Riley Purgatory Bluff Creek Watershed District Permit Application Review

Permit No: 2025-001

Project: Bluff 16 Culvert Replacement– The proposed project includes replacing the existing cast-in-place culvert conveying Riley Creek under the Minnesota River Bluffs LRT Regional Trail just north of Pioneer Trail.

Reviewer: Scott Sobiech, PE, Barr Engineering

EROSION CONTROL & TURF ESTABLISHMENT PLAN

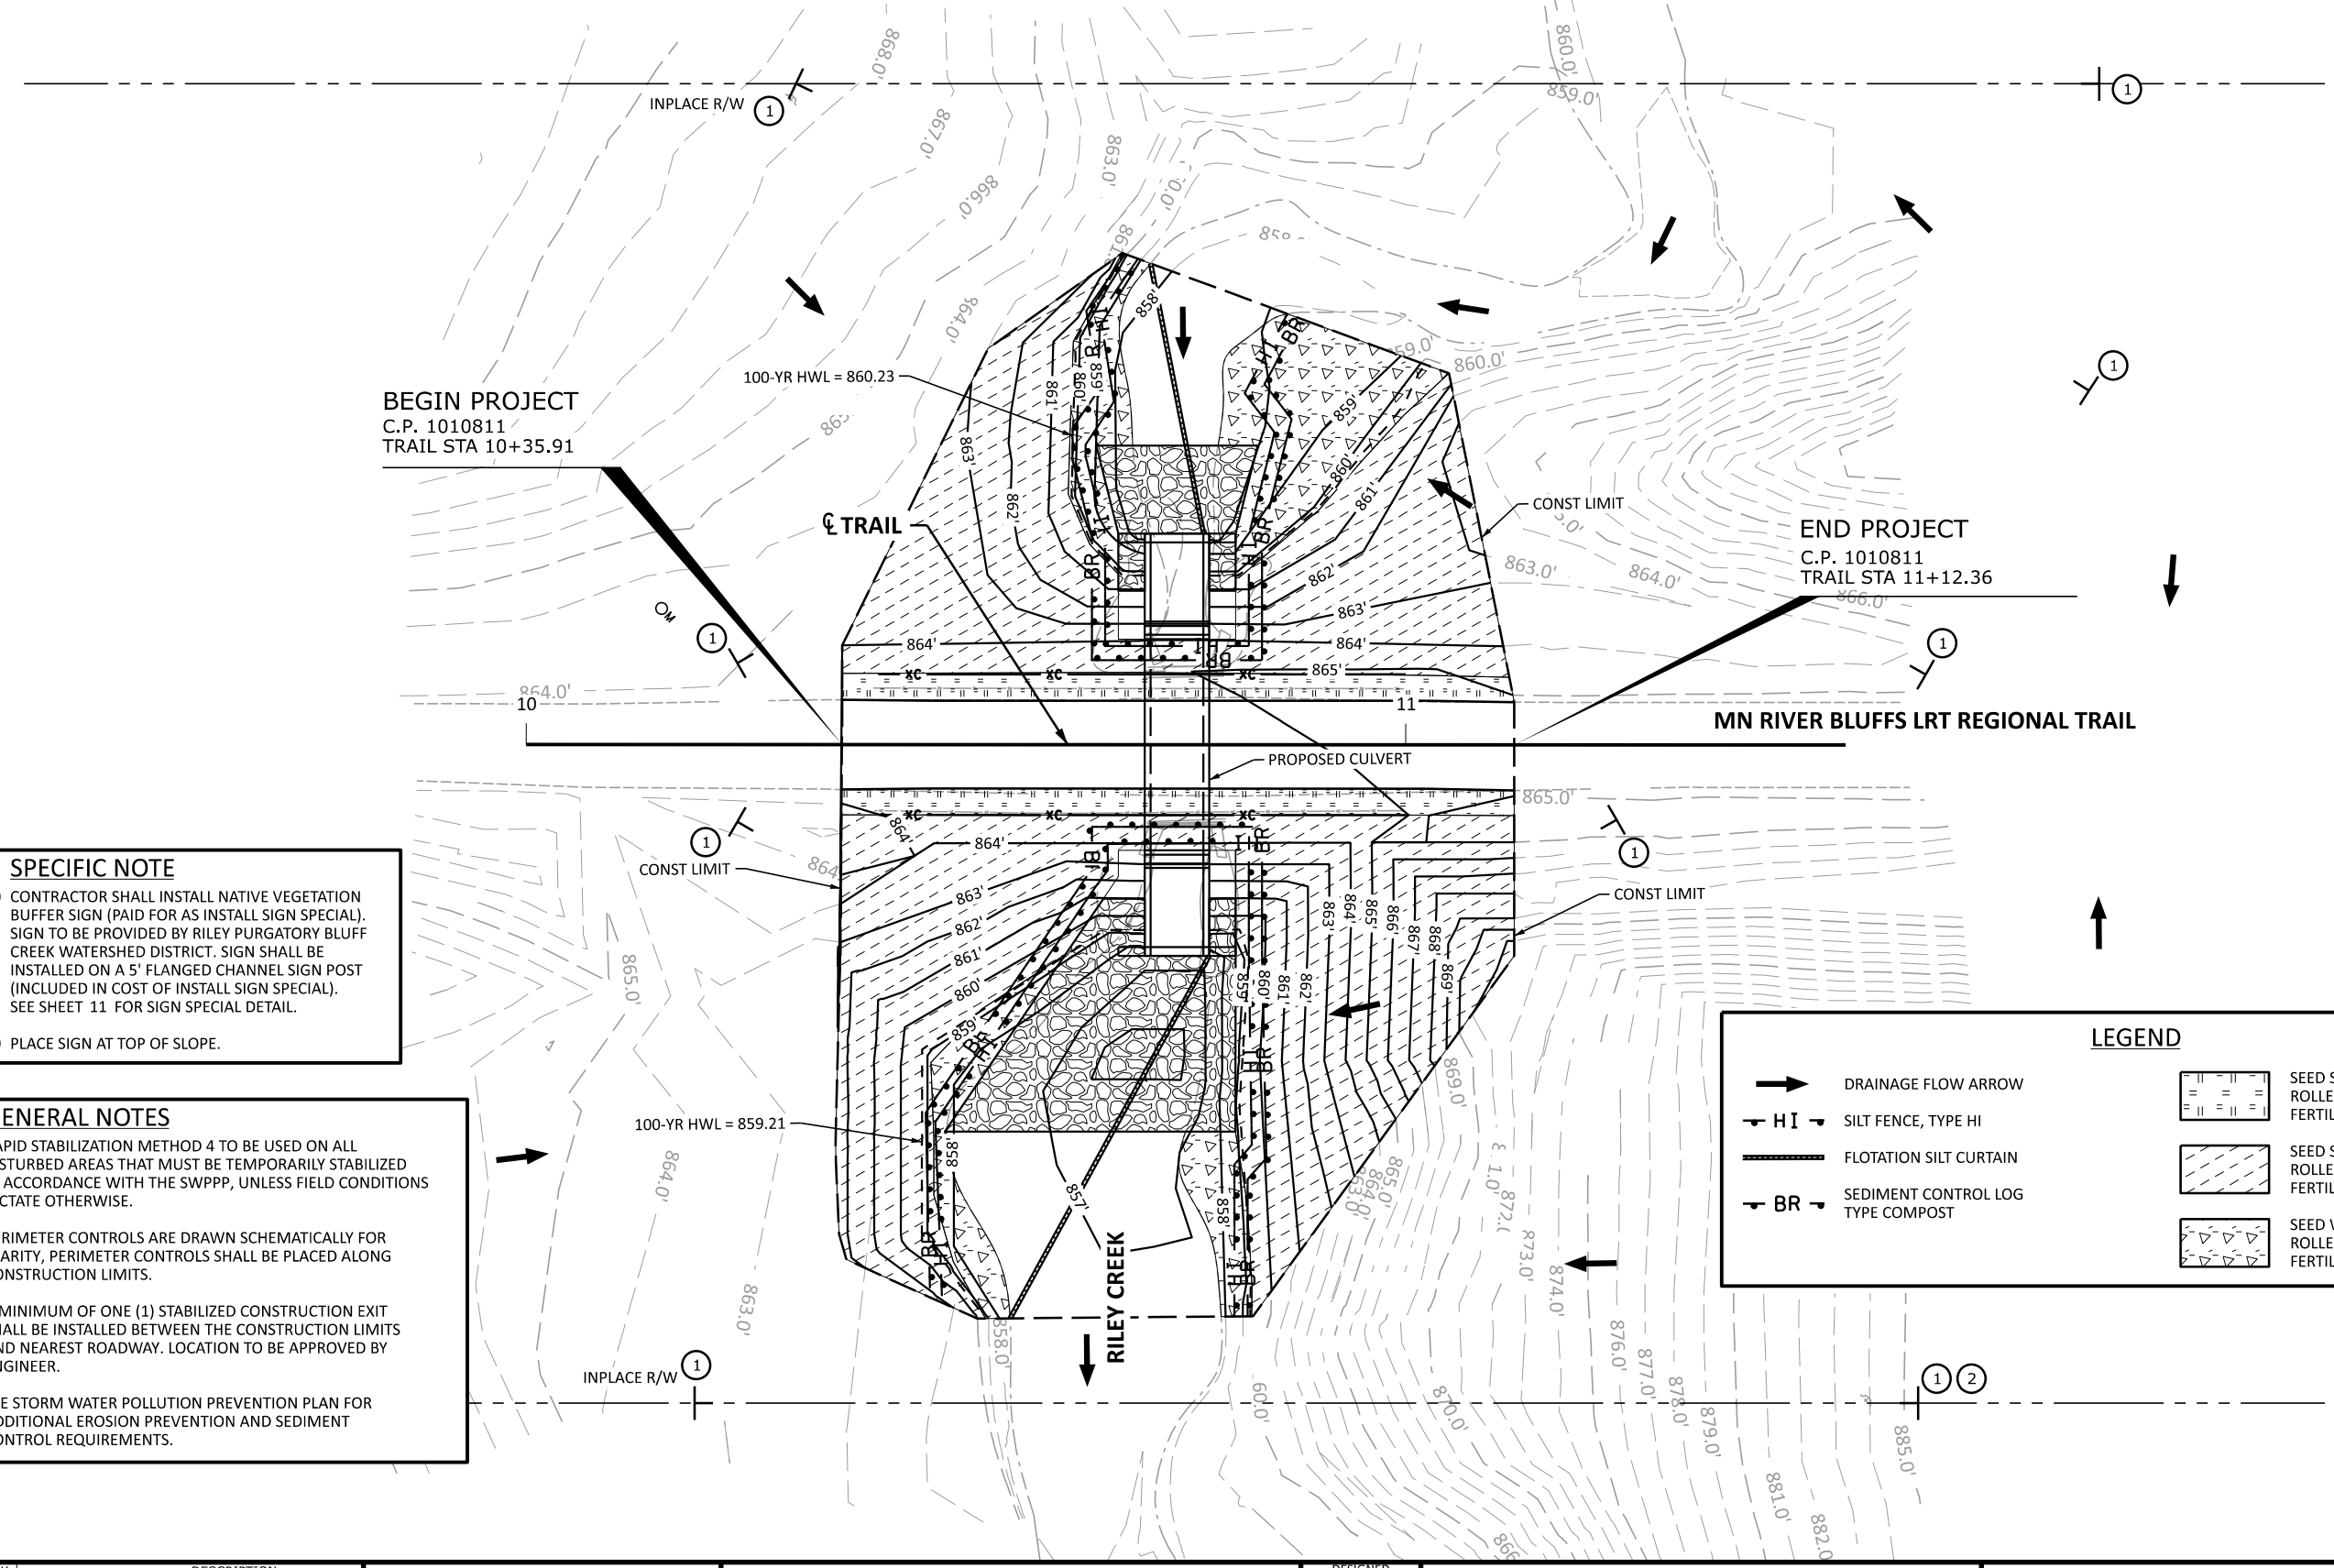
The erosion control/turf restoration plan prepared by the Bolton and Menk includes installation of silt fence, inlet protection for storm sewer catch basins, rock berm construction entrances, daily inspection, placement of a minimum of 6 inches of topsoil with 5 percent organic matter, decompaction of areas

compacted during construction, and retention of native topsoil onsite. To conform to the RPBCWD Rule C requirements the following revisions are needed:

- C1. The Applicant must provide the name and contact information of the individual responsible for erosion control at the site. RPBCWD must be notified if the responsible individual changes during the permit term.

Riley Creek flows through the project site and requires an average buffer width of 50 feet from the creek centerline, minimum 30 feet in accordance with Rule D, Subsection 3.2.b.v for a public waters watercourse. The erosion control/turf restoration plan shows the buffer zone and marker locations. Per Rule D, subsection 3.2c, the buffer must encompass all or part of a slope averaging 18% or greater. Because the drawing shows the buffer area extends to the top of slopes that average steeper than 18% the project conforms to Rule B, subsection 3.2c. As shown in the table below, the provided average buffer width to conform to the steep slopes provision (Rule B, subsection 3.2c) is greater than the required average buffer width to conform to Rule D, subsection 3.2.b.v, indicating that both requirements are met.

A note on the erosion control/turf restoration plan indicates the Applicant is proposing revegetating disturbed areas within the proposed buffer with native vegetation in conformance with Rule D, Subsection 3.3. A note is included on the plan sheet indicating the project will be constructed so as to minimize the potential transfer of aquatic invasive species (e.g., zebra mussels, Eurasian watermilfoil, etc.) to the maximum extent possible conforming to Rule D, Subsection 3.5.

1. Continued compliance with General Requirements.
2. The Applicant must provide the name and contact information of the individual responsible for erosion control at the site. RPBCWD must be notified if the responsible individual changes during the permit term.
3. Permit applicant must provide a draft maintenance agreement and inspection plan for the waterbody crossings and buffer areas. Once approved by RPBCWD, the HCRRA must enter an agreement with RPBCWD to maintain the project facilities in accordance with the plan.
